Project Name:	Horsham Enterprise Park (Lovells Site – Phases 1 & 2), Wimblehurst Road, Horsham
Document Reference:	183.0009/WCA/1
Document Name:	Walking and Cycling Audit
Prepared By:	Shannon Betteridge (November 2025)
Checked By:	Mark Smith (November 2025)
Approved By:	Mark Smith (November 2025)

Road Safety Audit Stage 1

Proposed Access Arrangements

Figure 2: Scope of Audit

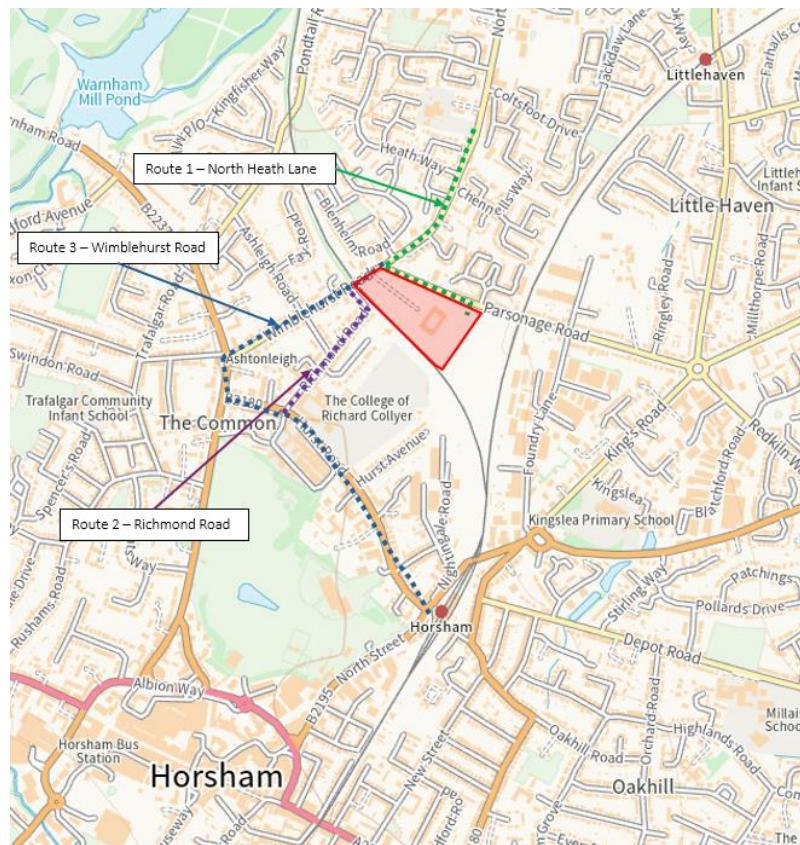
4.4 With consideration to the location of most of these facilities and amenities, **Figure 2** sets out the scope of the audit undertaken to review these routes further for their pedestrian infrastructure and opportunities.

Plan attached showing the locations of the problems identified as part of this audit (location numbers refer to paragraph numbers in the report).

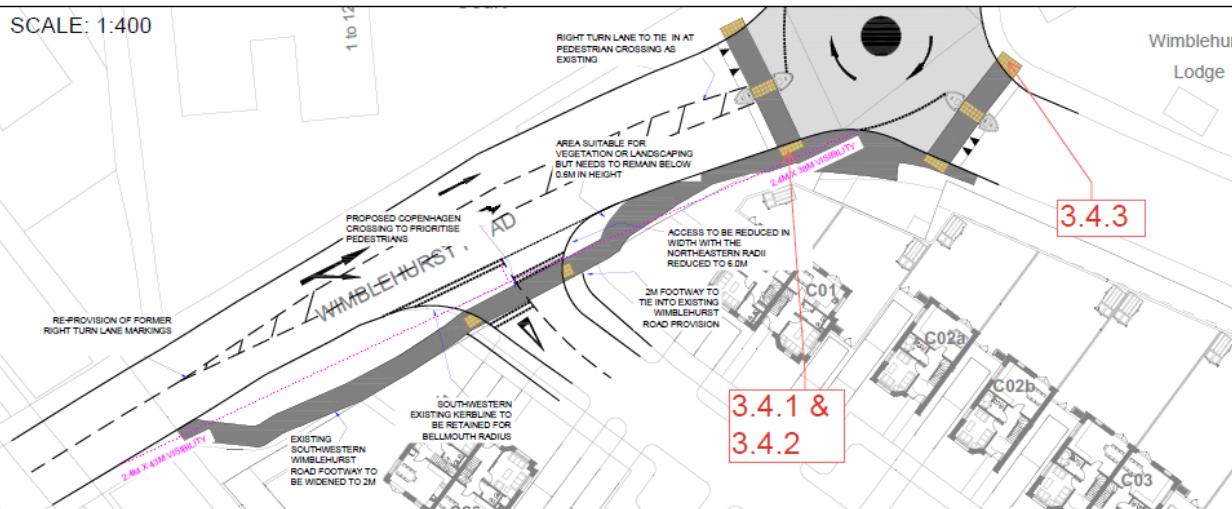
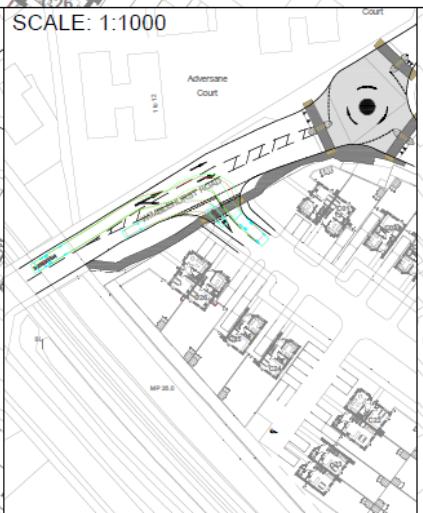
Location: Proposed pedestrian crossing point on the Wimblehurst Road arm of the roundabout, southeastern side of the carriageway.

Summary: Restricted visibility could lead to vehicle to pedestrian collisions.

No details relating to the pedestrian / traffic intervisibility splays at the crossing have been provided for assessment. There is concern that the hedgerow on the southwestern side of the Parsonage Road may restrict intervisibility, see figure 1 below. Restricted intervisibility could lead to vehicle to pedestrian collisions.

On the southeastern side of the carriageway of Wimblehurst Road there was evidence of ponding and detritus at the crossing point, see figure 2 below. To the northeast of the crossing point it was noted that the gully was blocked, see figure 3 below, which could lead to the ponding. There is concern that this detritus could be a slip hazard for pedestrians. Further, pedestrians may find a less safe place to cross, which could lead to vehicle to pedestrian collisions, particularly for visually and mobility impaired pedestrians.

It is recommended that the hedgerow be cut back and periodically maintained to retain visibility.

RSA Problem	RSA Recommendation	Design Organisation response)	Overseeing Organisation response	Agreed RSA action
3.4.1 Location: Proposed pedestrian crossing point on the Wimblehurst Road arm of the roundabout, southeastern side of the carriageway. Summary: Restricted visibility could lead to vehicle to pedestrian collisions. No details relating to the pedestrian / traffic intervisibility splays at the crossing have been provided for assessment. There is concern that the hedgerow on the southwestern side of the Parsonage Road may restrict intervisibility, see figure 1 below. Restricted intervisibility could lead to	It is recommended that the hedgerow be cut back and periodically maintained to retain visibility.	Noted and agreed. Any existing vegetation (within the highway or client's ownership) will be cleared and periodically maintained to ensure visibility splays remain clear.

vehicle to pedestrian collisions.				
<p>3.4.2</p> <p>Location: Proposed pedestrian crossing point on the Wimblehurst Road arm of the roundabout.</p> <p>Summary: Insufficient carriageway drainage could increase the risk of vehicle to pedestrian collisions.</p> <p>On the southeastern side of the carriageway of Wimblehurst Road there was evidence of ponding and detritus at the crossing point, see figure 2 below. To the northeast of the crossing point it was noted that the gully was blocked, see figure 3 below, which could lead to the ponding. There is concern that this detritus could be a slip hazard for pedestrians. Further, pedestrians may find a less safe place to cross, which could lead to vehicle to pedestrian collisions, particularly for visually and mobility impaired pedestrians.</p>	<p>It is recommended that the gully be cleared, and the detritus removed.</p>	<p>Noted and agreed. Gullies will be cleared and periodically maintained to prevent ponding and ensure there are no drainage issues.</p> <p>The roundabout is no longer proposed to be raised which should address these concerns, but the development will pay contributions towards the delivery of tactile paving and dropped kerbs that are currently lacking on the Parsonage Road and Wimblehurst Road arms – thus improving the routes for pedestrians and visually/mobility impaired users.</p>
